Comments 1 thru 22 below are for information only. No response is required. The comments are intended to assist in progressing the DBF's concept to 90%.

4. Sheet B-4:

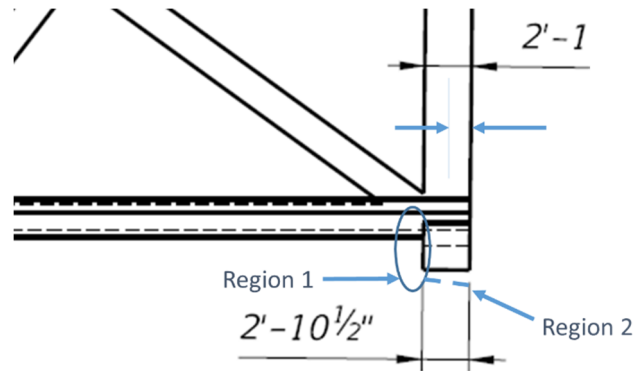
- a. Show cross slope on both sides of the section.
- b. Gradual drainage pipe slopes will be difficult to maintain. Greater slopes would be self-cleaning. Also design-in sufficient longitudinal slope of canopy to avoid ponding water.

Provide pipe cleanout details during final design and verify that 8 inch diameter pipe is sufficient.

8. Sheets B-9 and B-10:

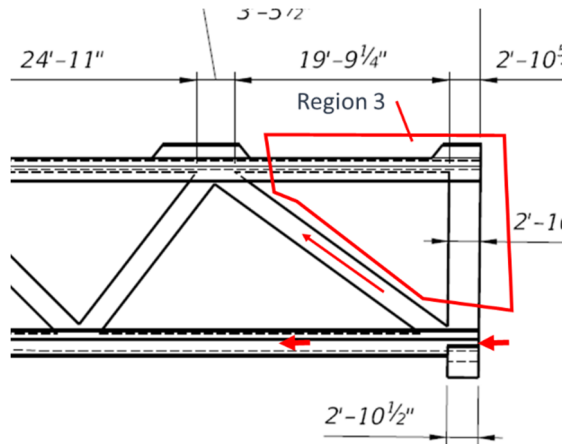
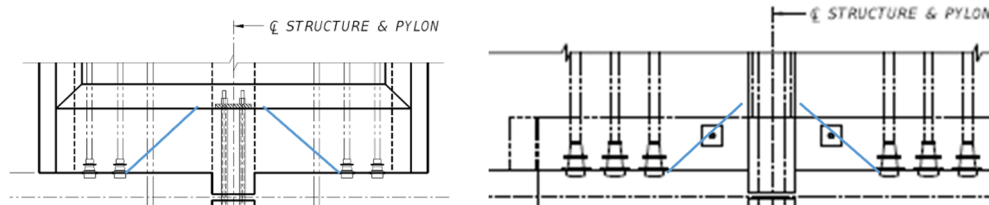
- a. Care needs to be taken to avoid issues associated with elastic shortening of the elements during stressing of longitudinal tendons. For instance the form has to be designed to be compressible or removable (region 1), and embedded skid plates need to be embedded in such a way that the heel does not spall or crack as the element cambers up and drags on its heel (region 2).

- b. The plans need to clearly show the sequence of all stressing. Maintaining stress limits throughout all intermittent phases to avoid cracking of the members will be extremely tricky and will likely necessitate stressing all web members along with some transverse/longitudinal stressing in increments such that members stay in compression. Also predicting where the PT stressing actually goes will be tricky. For instance any forces imposed on web joints affect all members framing into the joint. Longitudinal stressing of the canopy/walkway will tend to go into the stiff web element and not in the canopy/walkway. Also the design needs to pay particular shear lag affects and member interface shear (horizontal shear) through all phases of stressing.

- c. There is a concern with tension behind the compression zone due to longitudinal PT of the walkway at the member ends as the top of the web and canopy element gets dragged along (shear lag in region 3).

- d. There appears to be significant shear lag issues in both the canopy and walkway as the stiff web element is being dragged behind the compression zone. The designer needs to pay particular attention in these areas. Moving the canopy continuity tendon to the middle tendon spot may improve the issue. Consider adding additional longitudinal tendons in the added 2 ft. corner chamfers (Comment 4.c.i).

- b. The 3 3/4" distance to the flat duct is insufficient when accounting for an outer duct diameter of 1.54". See SDG Table 1.11.4-1.
 11. Sheet B-16:

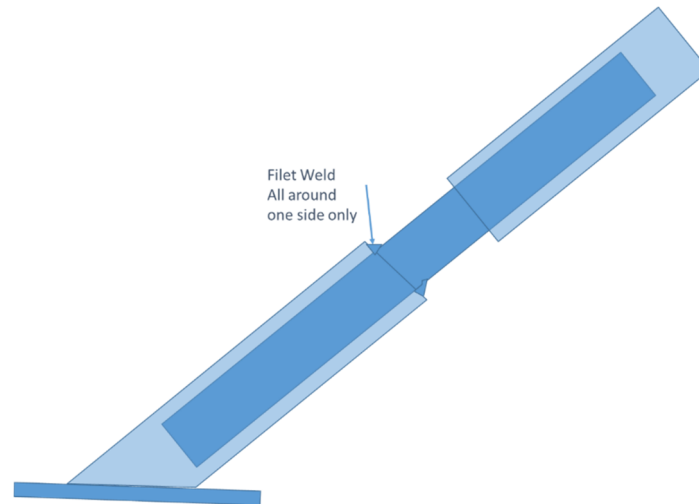
- a. The longest pipe (145'-9") will deflect 2.44 inches under its own dead load. This assumes a standard pipe wall thickness. Even thicker walled 16 inch pipes appear to be unacceptable solutions. Consider a 20 inch or 24 inch O.D. with an X-Heavy wall thickness for the longest pipe and a standard pipe thickness for the rest.

- b. Are the anchor bolts to be embedded in the members? Avoid drill and epoxy options if possible. See suggested detail below in item C to facilitate fit-up.

- c. The pipes will be a maintenance issue long term. Will they be galvanized and then painted. How will inside of pipe be maintained if it is not galvanized? Pipes will attract live loads, thermal loads, and wind loads. See suggested detail (tight fitting inner slide pipe) below to avoid stressing of the pipes. Require pipes to be completely sealed against rain intrusion.

12. Sheet B-17:

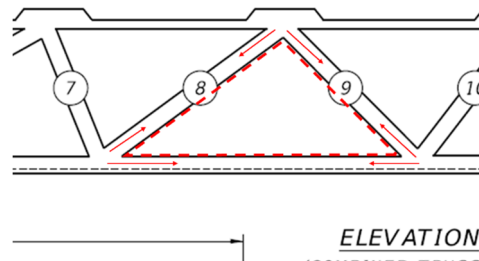
- a. See comment 8 above regarding providing a detailed stressing sequence. All web members may have to be stressed (even members 1, 9, 11 thru 14 and 24) to avoid cracking. See Comment 8.c above.
- b. The PT bars at the bottom joint intersection member 7 and 8 conflict (the bars are in the same vertical plane).
- c. In the case where the bars are stressed from the bottom, how is stressing accessed? Also if an anchor recess is provided at this location, the recess will weaken the member.
- d. Include reinforcing and bursting steel details in the next submittal.
- e. Recommend showing section views for members without PT bars.

- f. The web truss will be very difficult to form without shrinkage cracking of the geometrically constrained members. Concrete placed around rigid inner forms are prone to shrinkage cracking and difficult to strip without damaging the member. See sketch below. Also over the length of the web element how will shrinkage be facilitated – will the inner forms be allowed to float or will the element be cast in stages? Recommend a shrinkage reducing admixture, a staged construction process and possibly call-for all of the inner forms to be lined with thin compressible rubber liners.
